Contract Addendum

SUBJECT: **Prime SP:** 5680-147 **CONTRACT ID:** 250007

State Project No.: 5680-147 (TH 94=064), 8480-43 (TH 94=064)

Addendum No.: 2

SHEET NO. 12 R

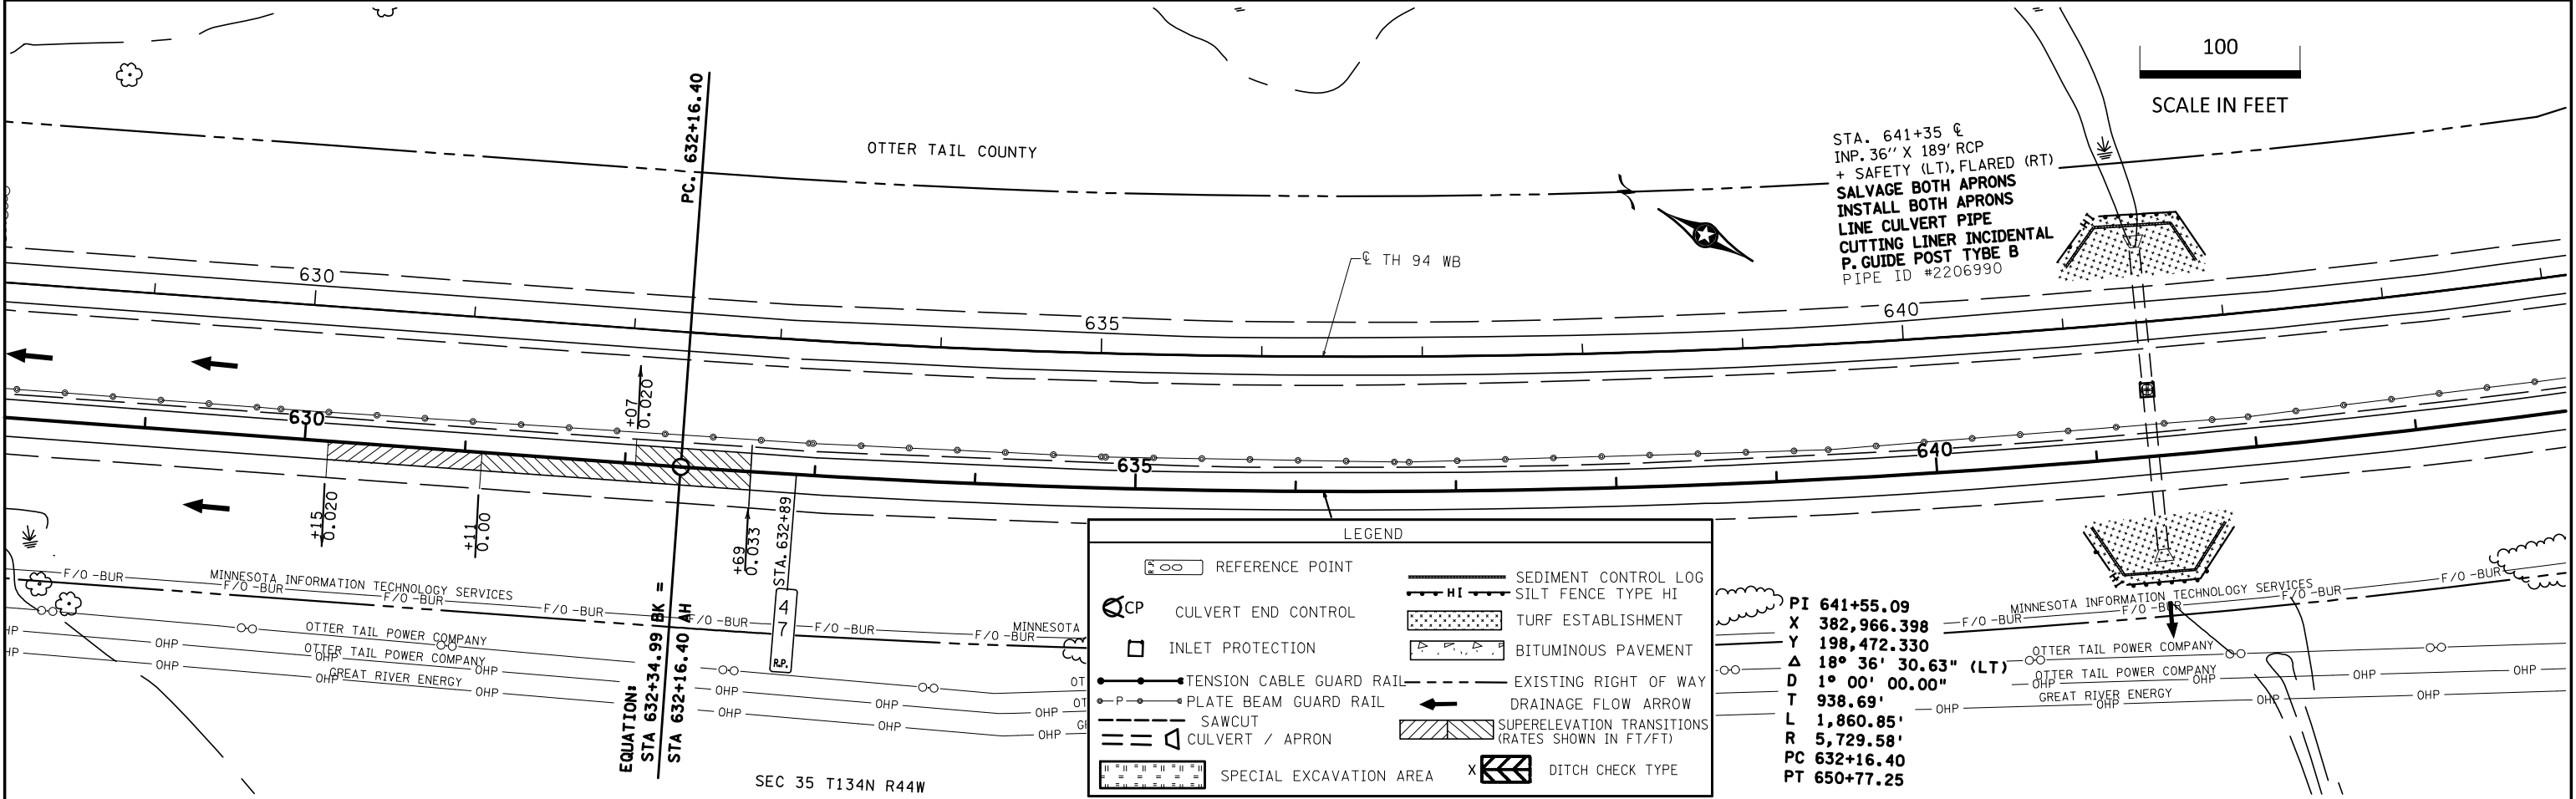
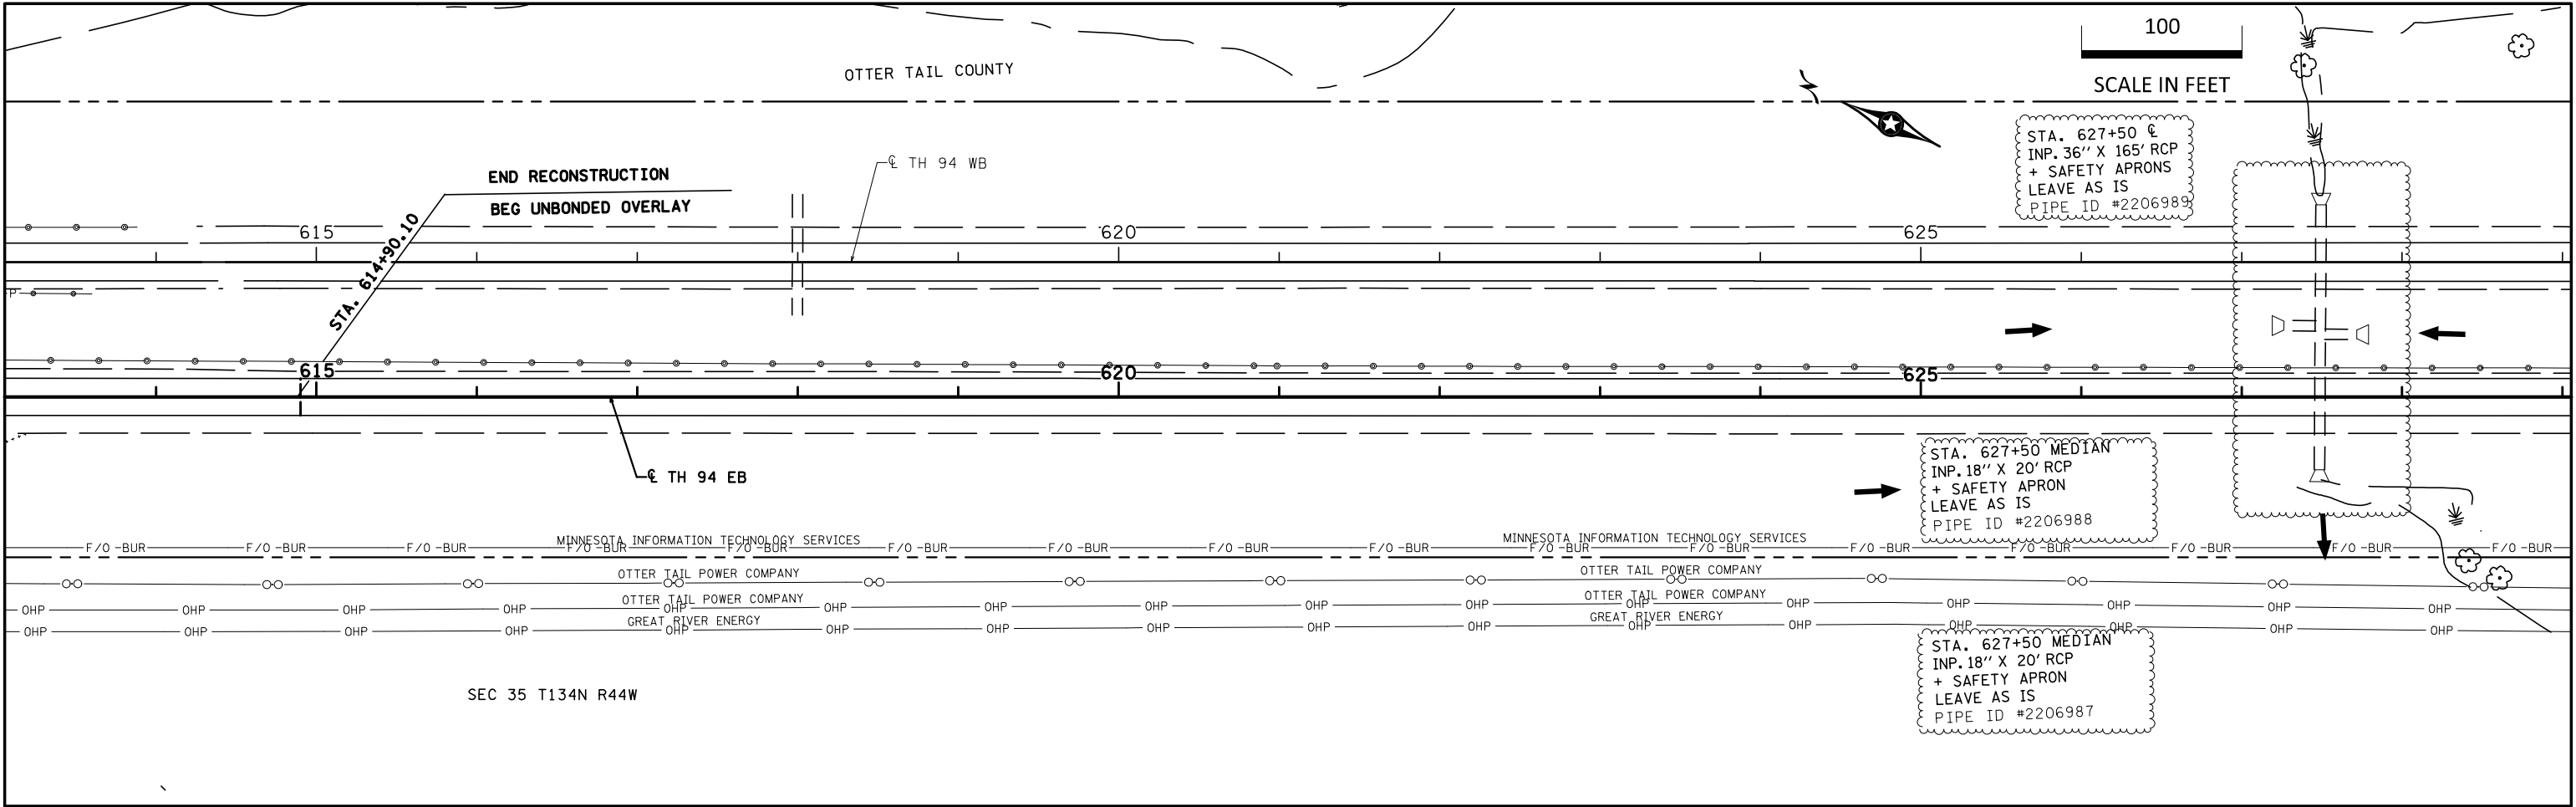
ADDED QUANTITY FOR WB STRIPING

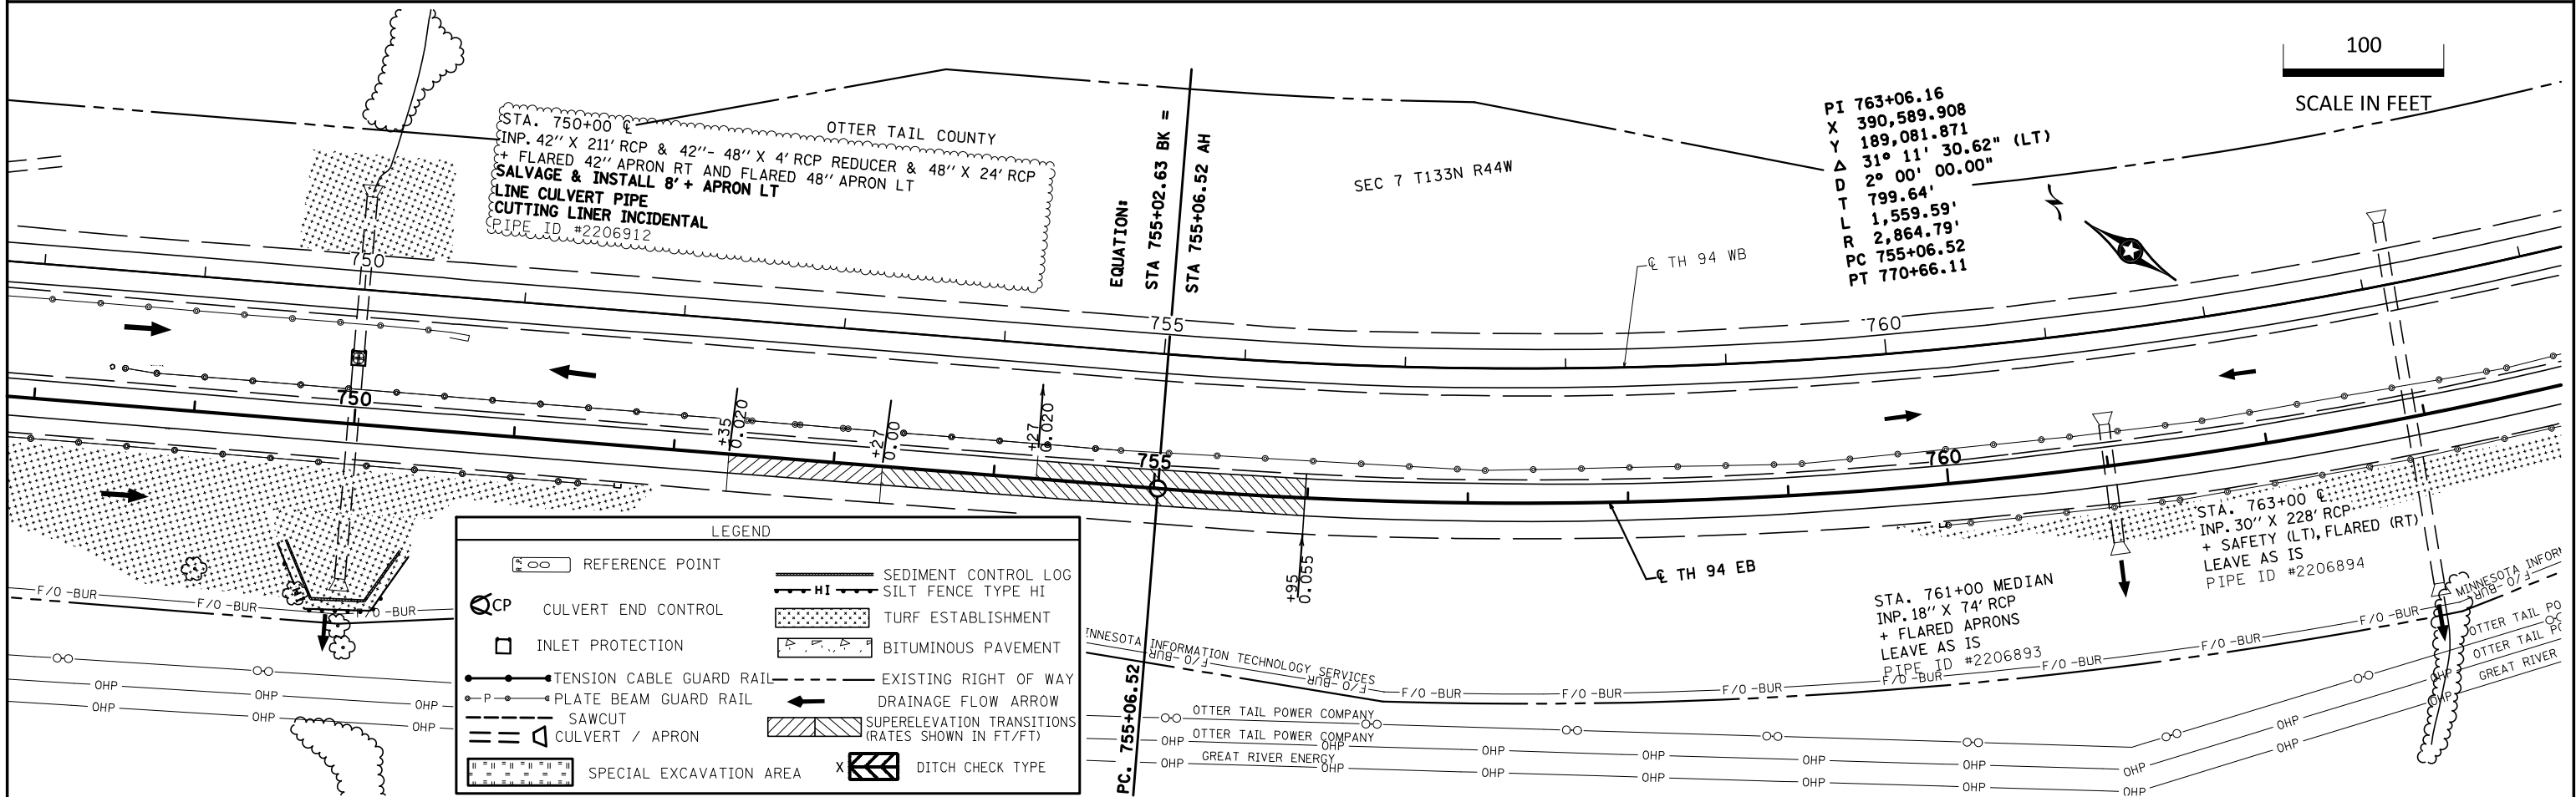
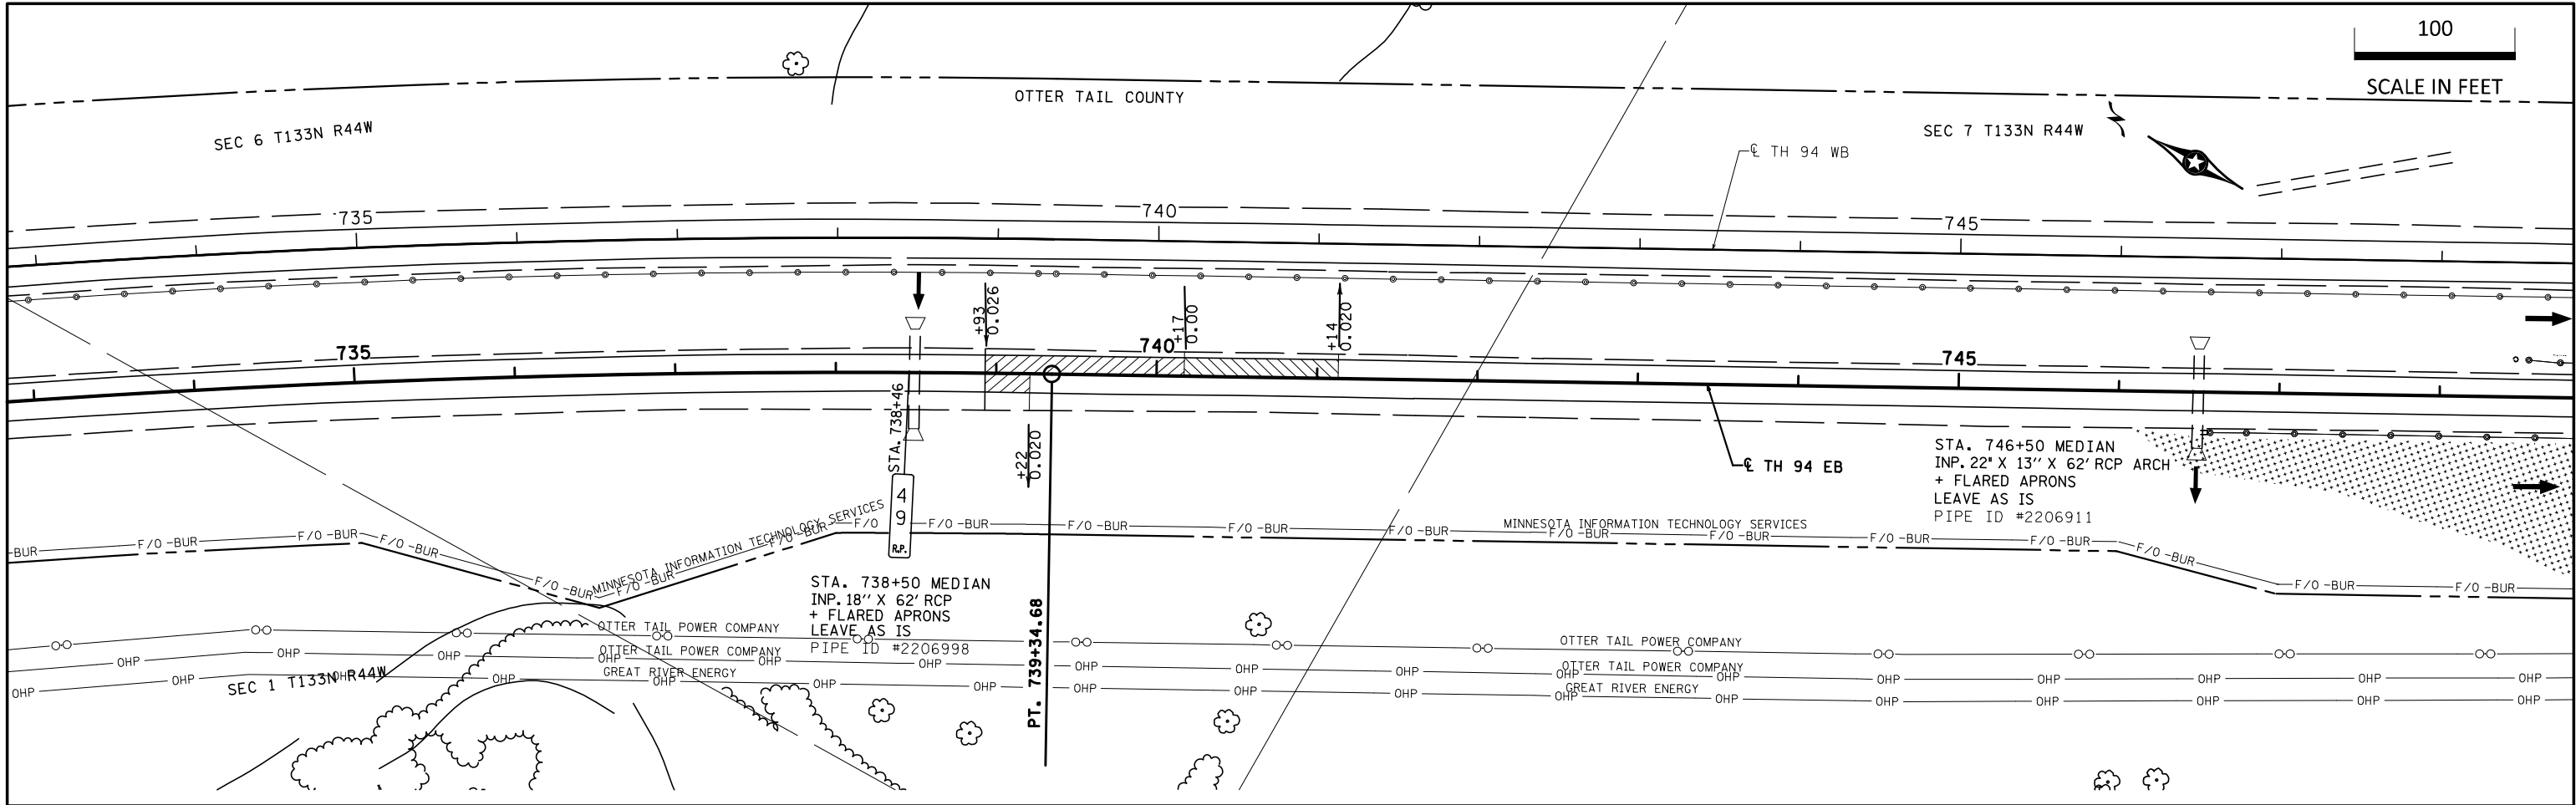
PLAN REVISIONS				ANDREW KROG LIC. NO. 54689 DATE: 10-JAN-2025	I HEREBY CERTIFY THAT THIS PLAN SHEET WAS PREPARED BY ME OR UNDER MY DIRECT SUPERVISION AND THAT I AM A DULY LICENSED PROFESSIONAL ENGINEER UNDER THE LAWS OF THE STATE OF MINNESOTA.	CONSTRUCTION PLANS	STATE PROJ. NO. 5680-147		SHEET NO. 107R	
DATE	REVISION	APPROVER					(TH 94)		TOTAL SHEETS 153	
1/10/2025	REMOVED PIPE WORK AT STA 627+50	A.K.
